WORK TO BE PERFORMED UNDER THIS PROJECT INCLUDES THE CONSTRUCTION OF A NORTHBOUND LEFT TURN LANE, AND INSTALLING A SIGNALIZED TRAFFIC SYSTEM, WITH RELATED PAVEMENT MARKINGS AND SIGNS.

CONTRACTOR: ENGINEERS CONSTRUCTION, INC. - SO. BURLINGTON, VT
RESIDENT ENGINEER: T. POCKETTE
CONSTRUCTION BEGAN: JULY 5, 2005
CONSTRUCTION COMPLETE: NOVEMBER 13, 2005
RECORD PLANS BY: T. POCKETTE & N. GARBACIK

PROJECT NAME : **CLARENDON**
PROJECT NUMBER : **NHG SGNL (24)**

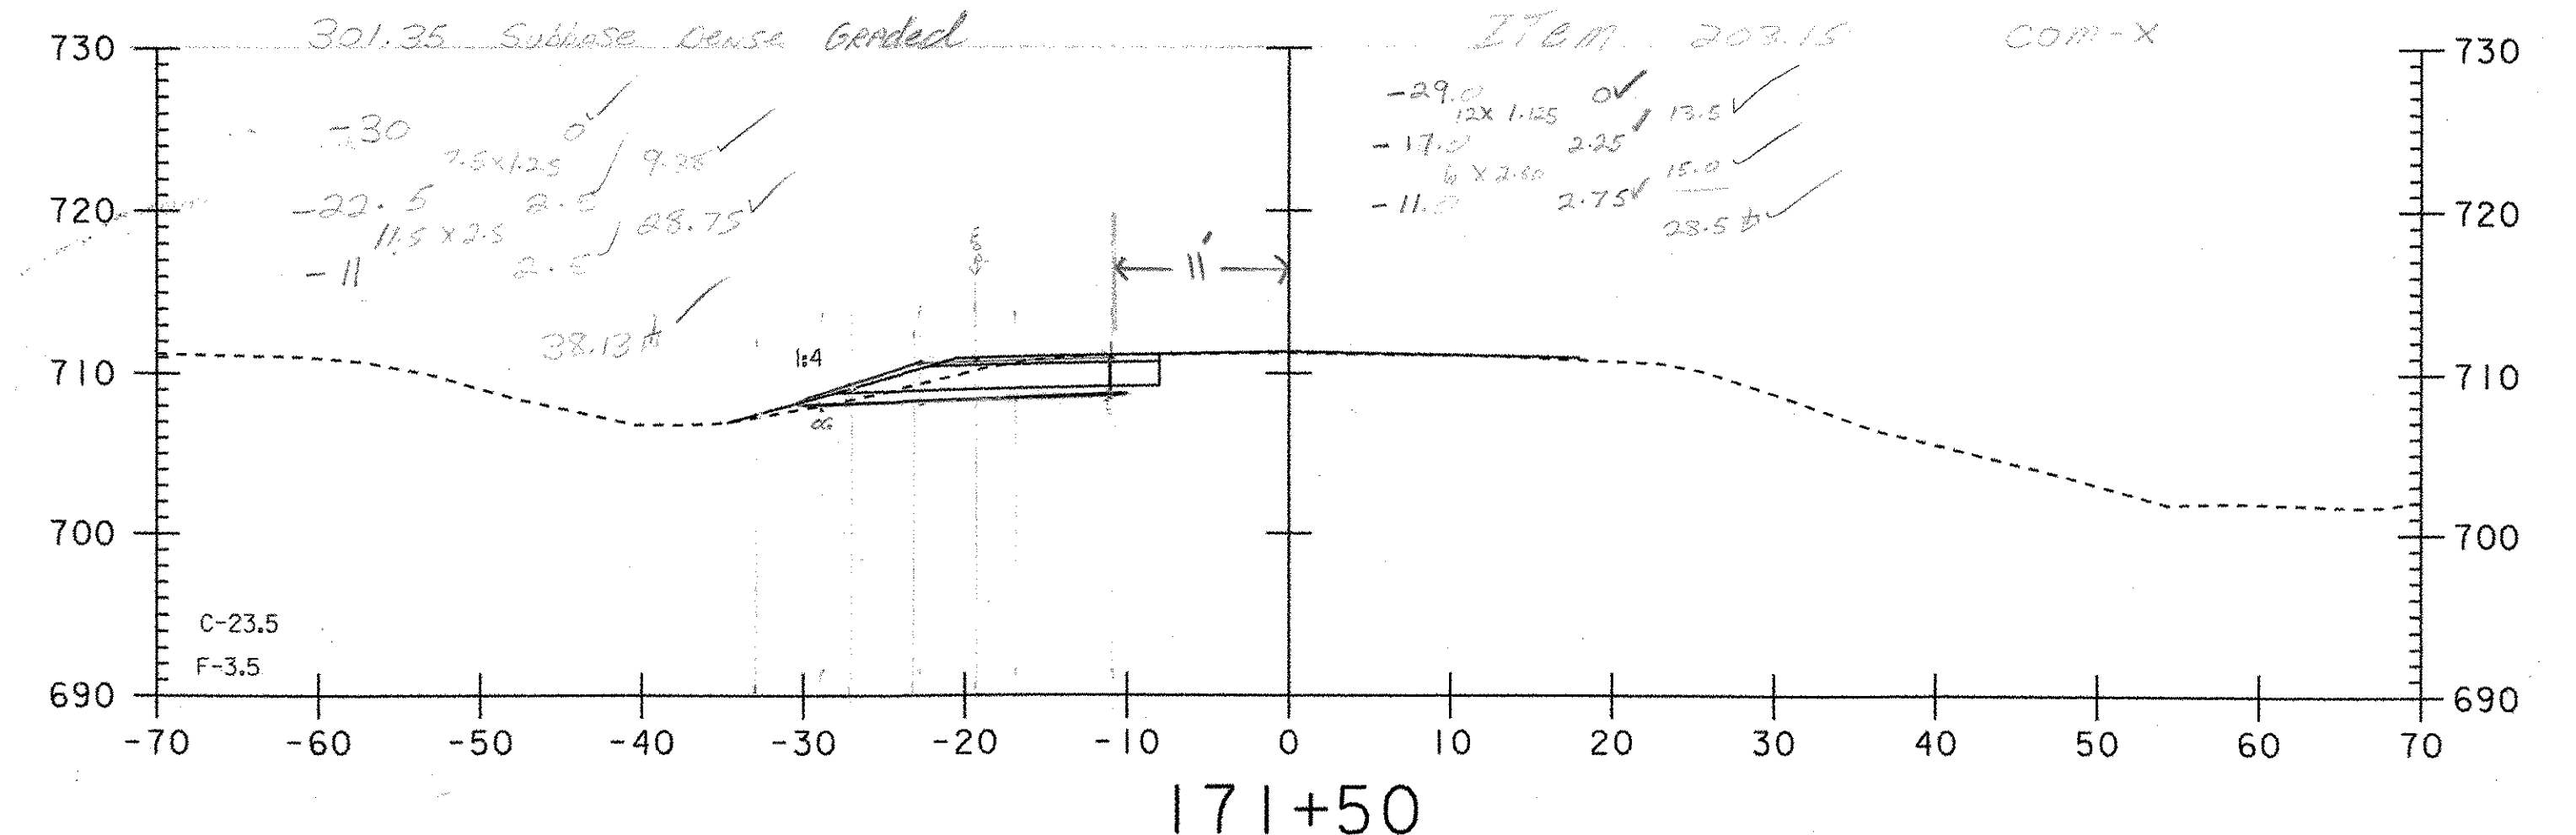
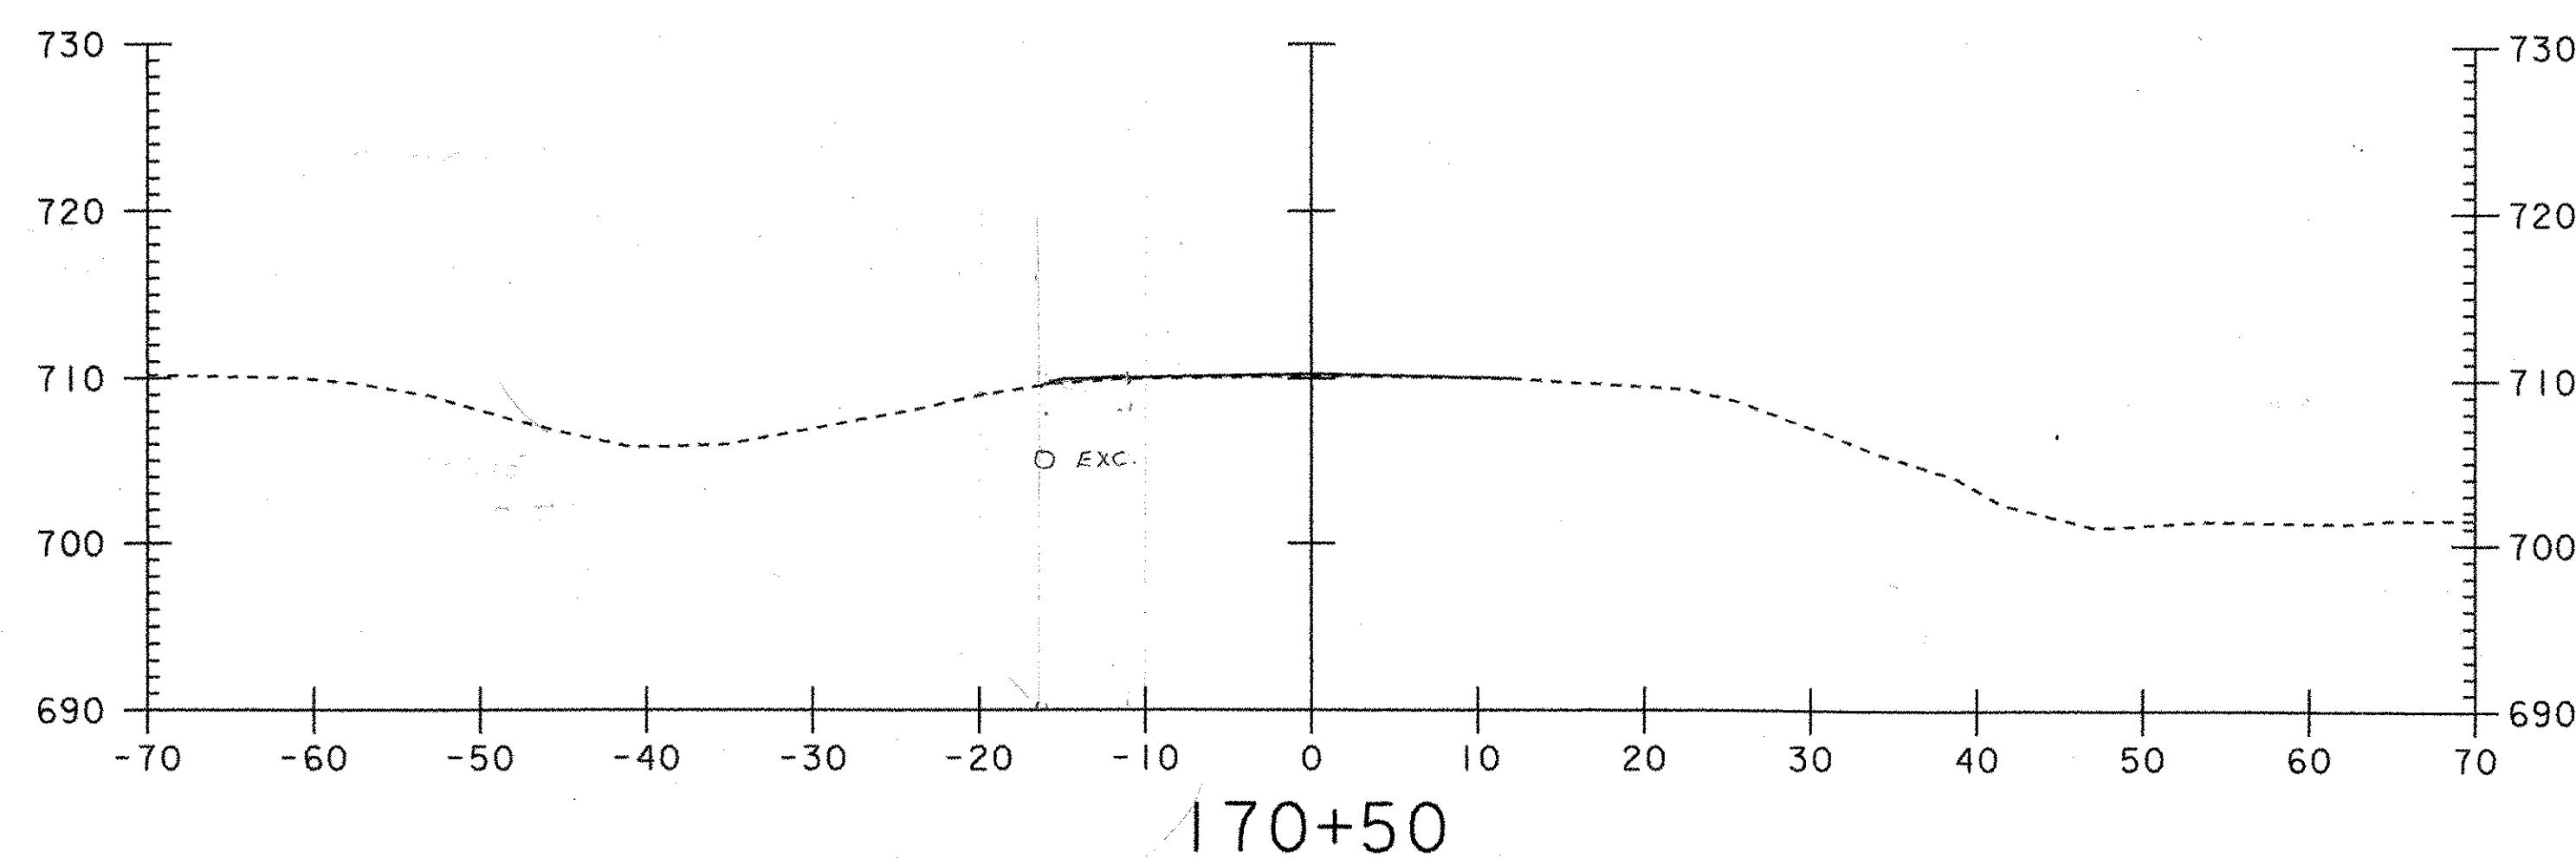
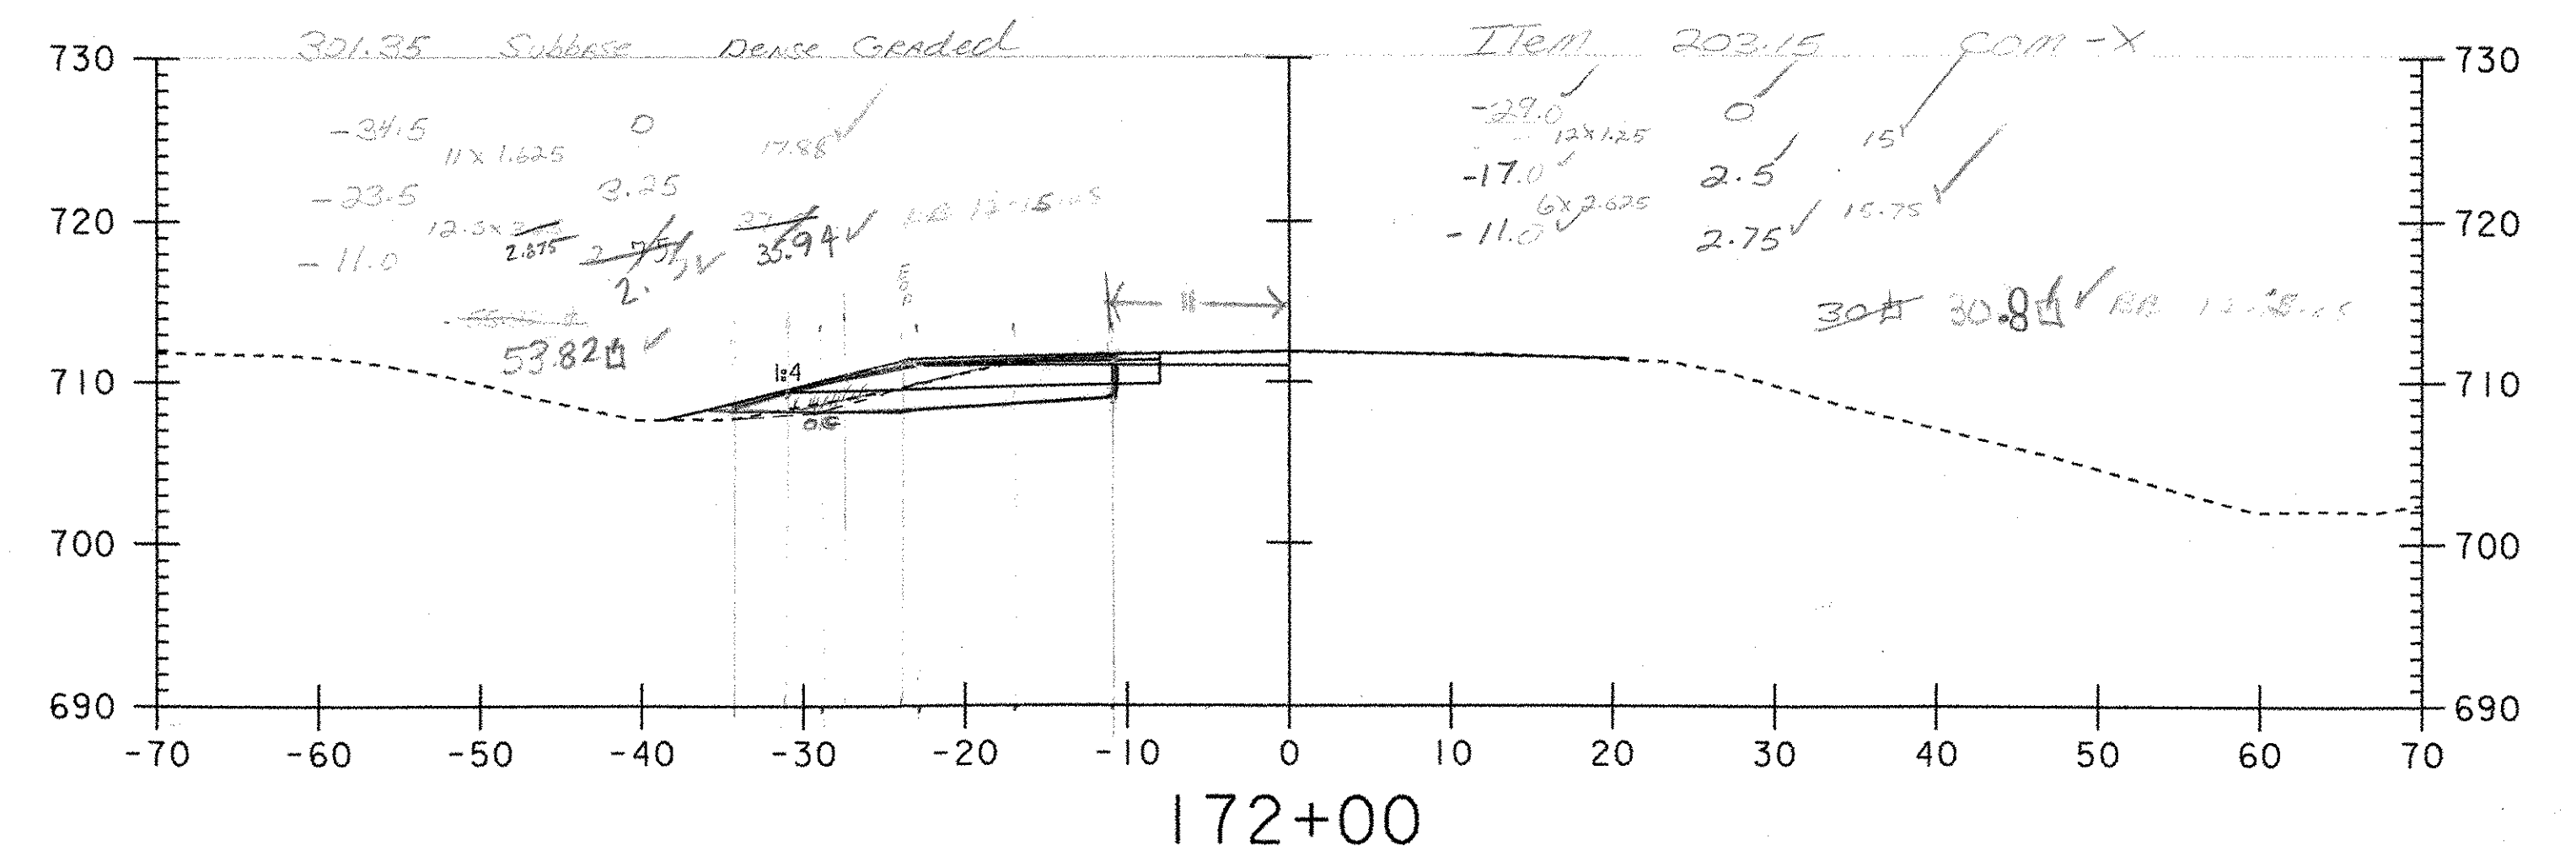
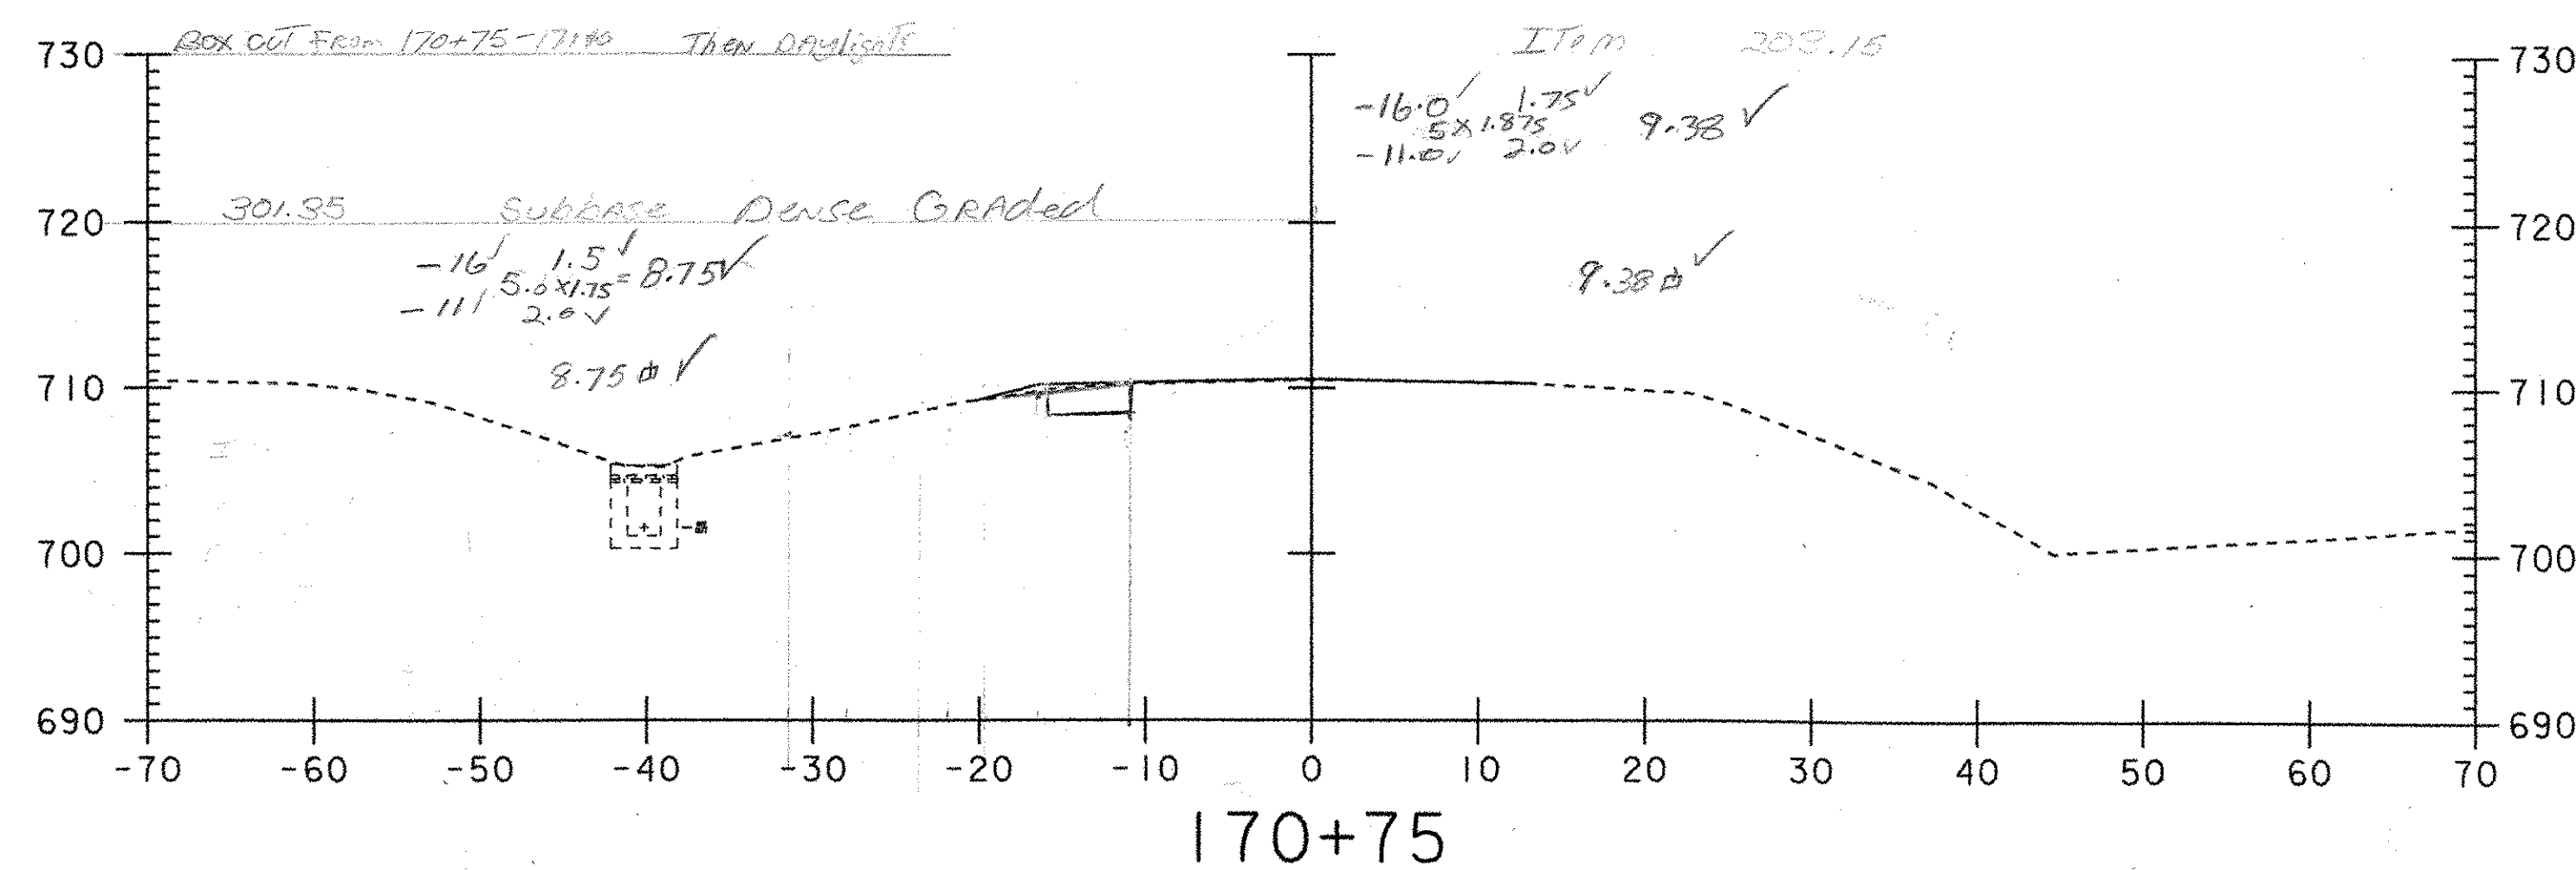
ITEM 203.15 - Common Excavation
 Quantities sent to Spreadsheet for
 final Quantities. See Sheets
 203.15-1 to 203.15-2 for details. (TP)

ITEM 301.35 - Subbase of Dense Graded Crushed Stone
 Quantities sent to Spreadsheet for
 final Quantities. See Sheets
 301.35-1 to 301.35-2 for details. (TP)
